**TOWN OF GRANITE QUARRY
PLANNING BOARD
REGULAR MEETING AGENDA
March 6, 2023
6:00 p.m.**

Subject: CD-PUD (Conditional District-Planned Unit Development)
Case #: ZO-23-02
Project Address: TBA N Salisbury Ave./Stokes Ferry Rd.
Project Tax Parcel#: 066 047
Property Owners: Florence Sifford Heirs
Applicant: Belle Realty Development Inc. (Wallace Realty)
Current Zoning: RL (Residential Low Density) & OI (Office & Institutional)
Action Date: Planning Board- March 6th, 2023
Request: Rezone from RL & OI to CD-PUD with Site Plan

SIFFORD RESIDENTIAL SUBDIVISION

Project Name: "Sifford" PUD Subdivision **Revision**

Elevation - Left
1/4" = 1'-0"

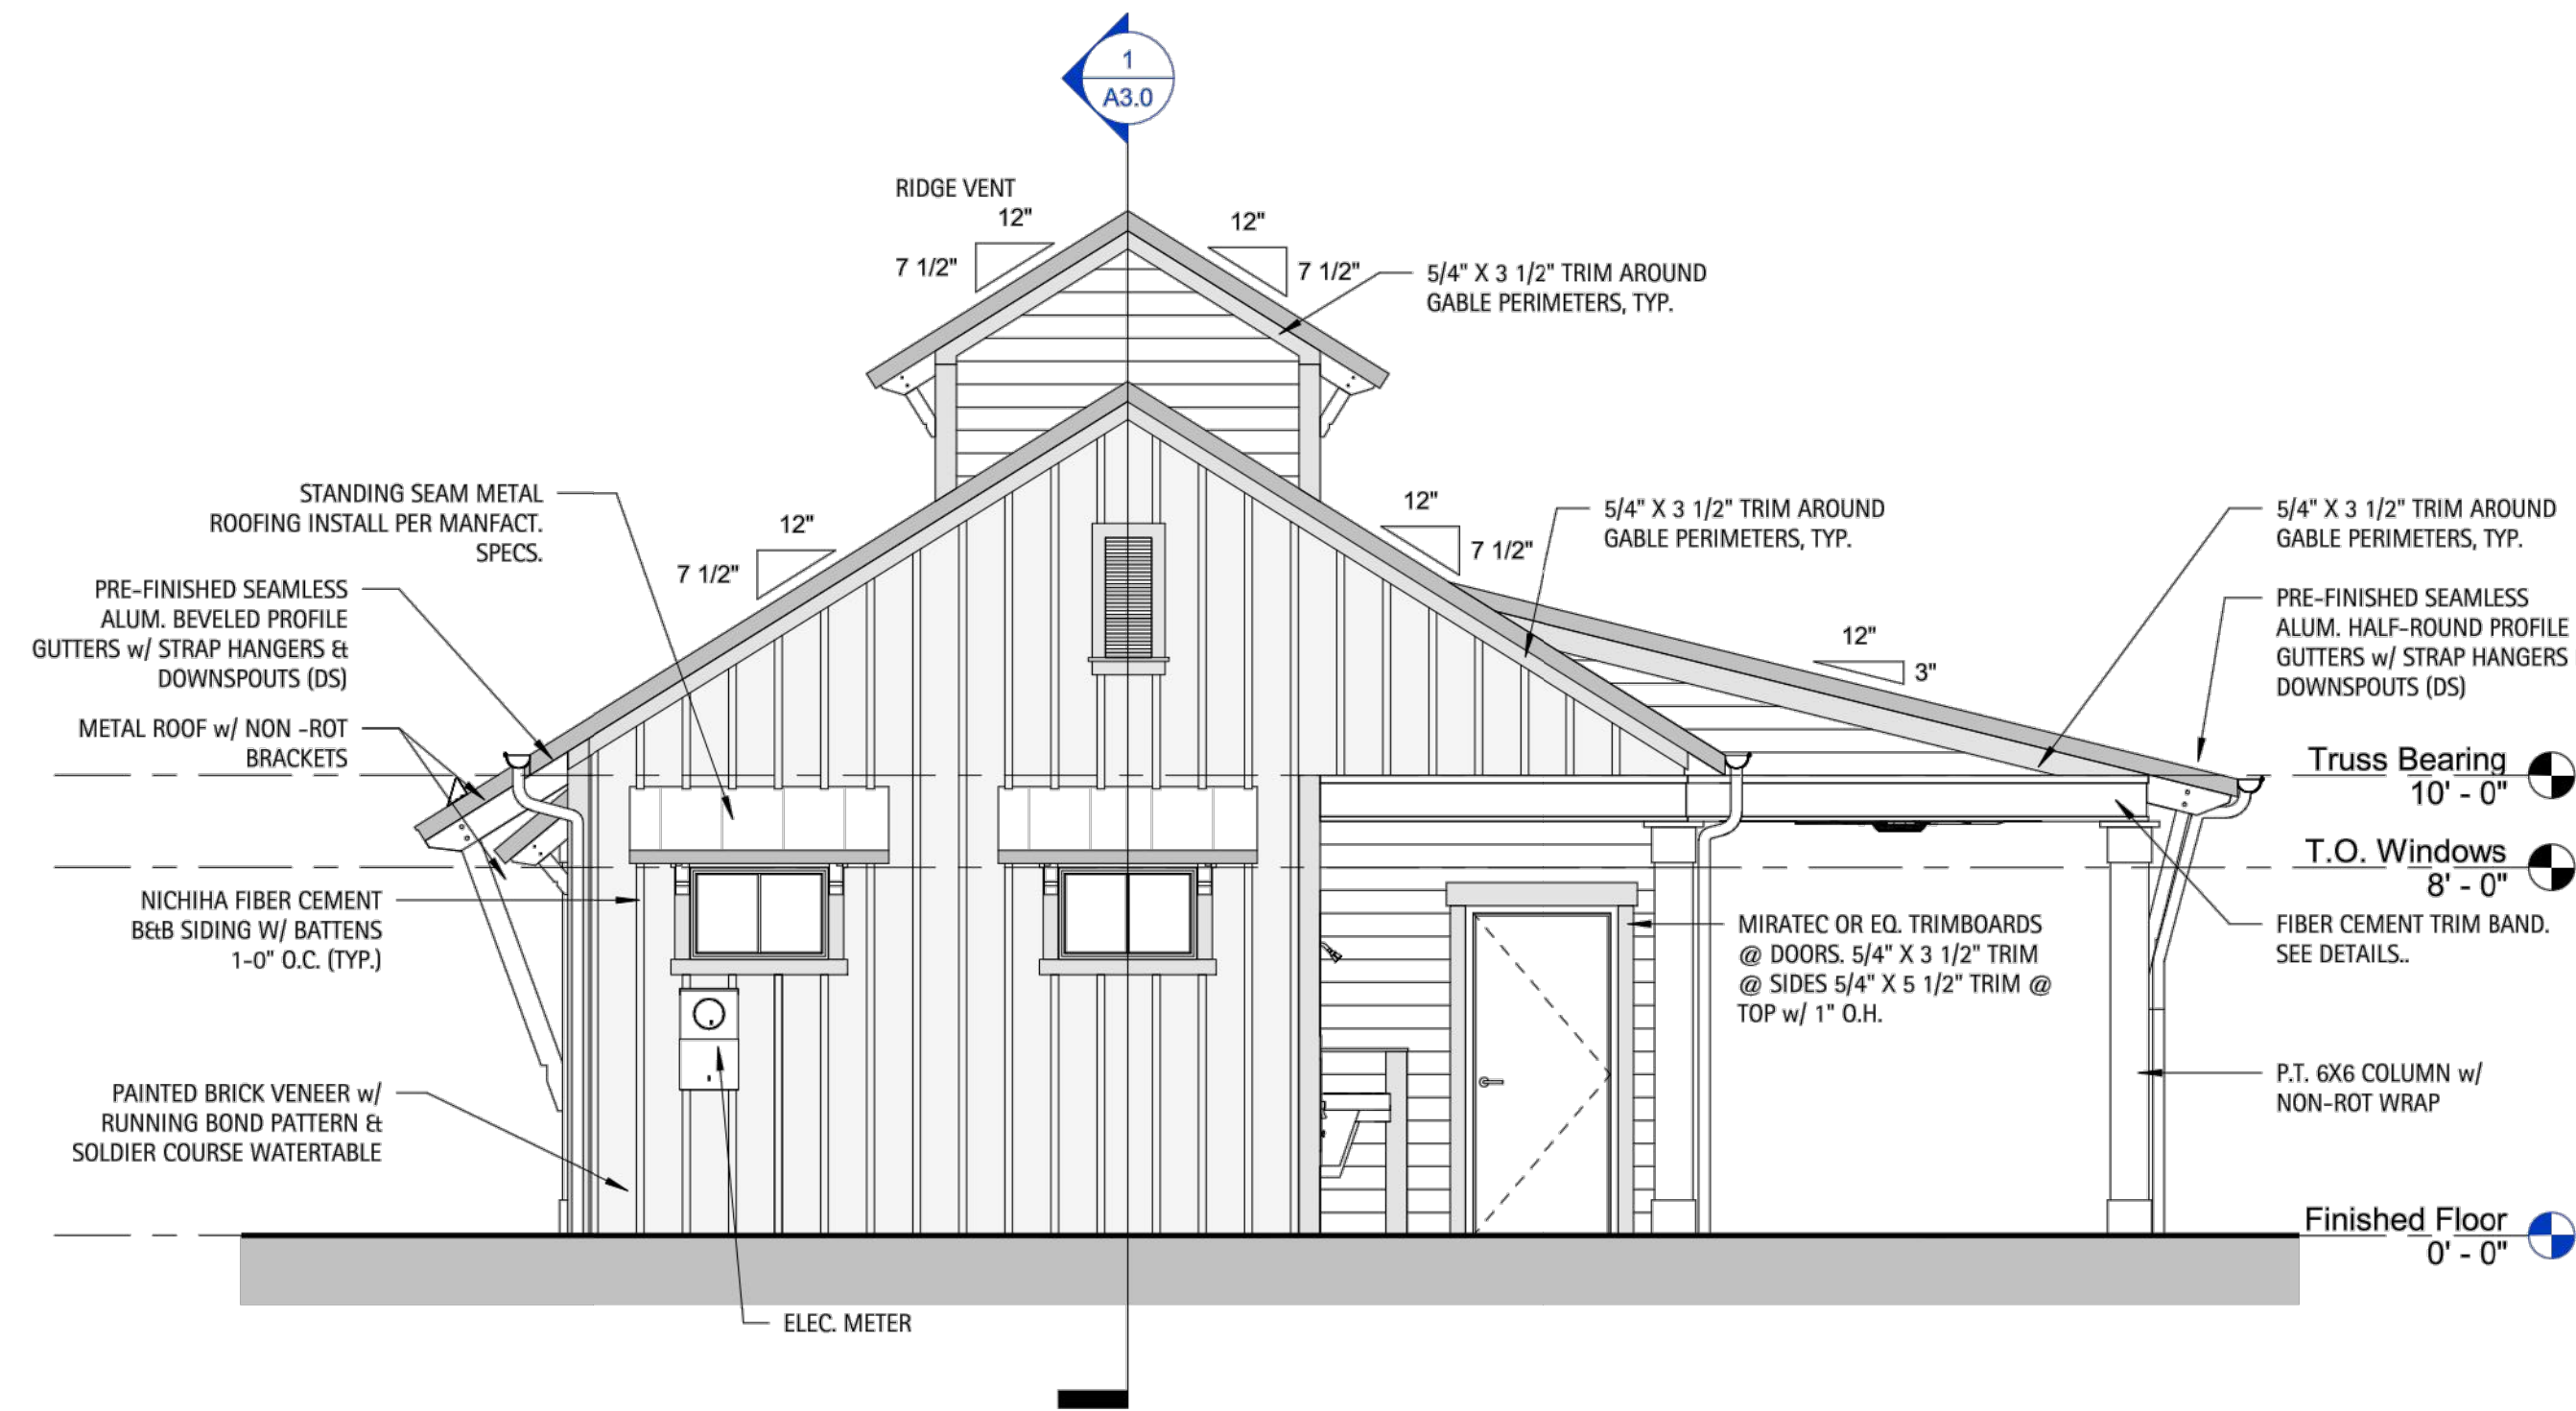
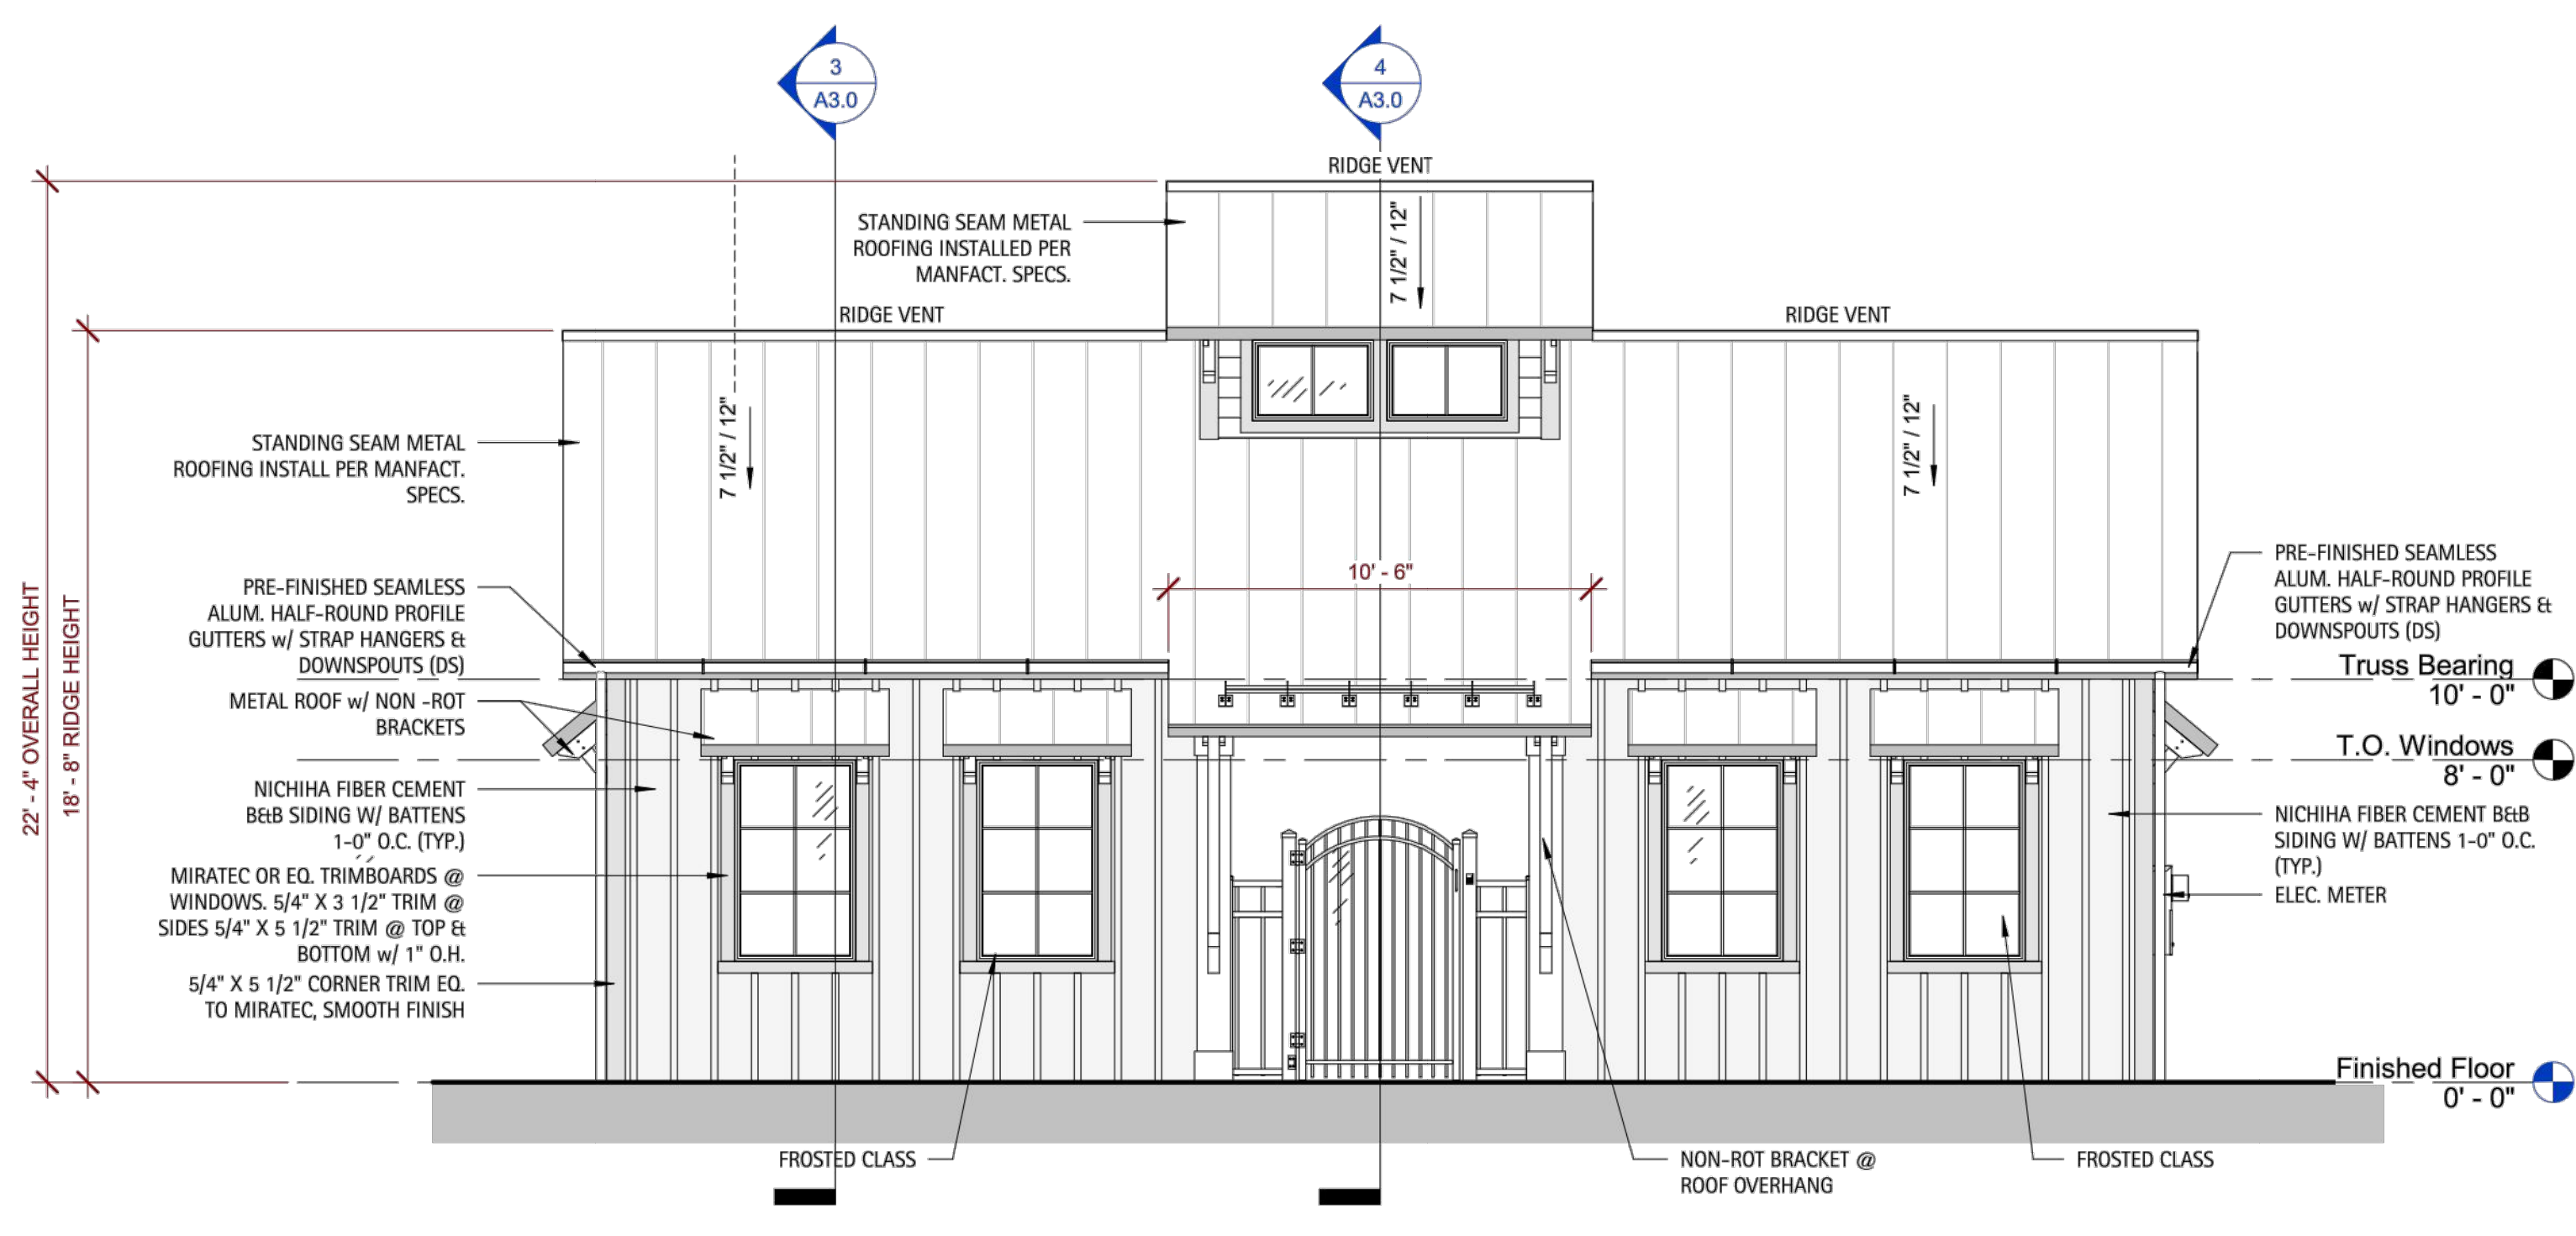
- Would prefer to see amenities center more centrally located or add additional amenities area in Phase III
- Pool is mentioned at amenities center but no location shown unless indoors
